HiPAP® Transceiver x81

Information letter

HiPAP® Transceiver x81 backplane improvements

Picture 1 shows the old connectors reported with problems.

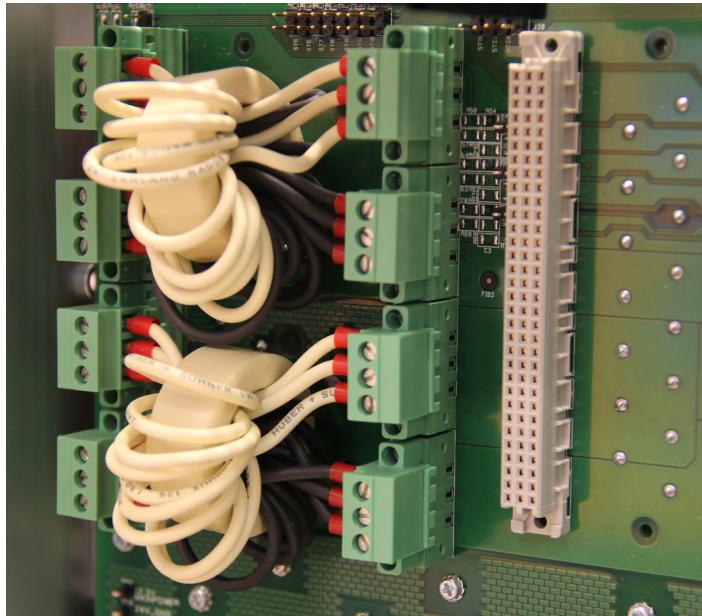
It has been reported that connectors connecting the solenoids L1 and L2 to the HiPAP Transceiver backplane are burnt on some installations. P3, P4, P5 and P6 for L1 and P7, P8, P9 and P18 for L2.

The connectors are replaced with terminal blocks on the new backplanes to avoid this problem.
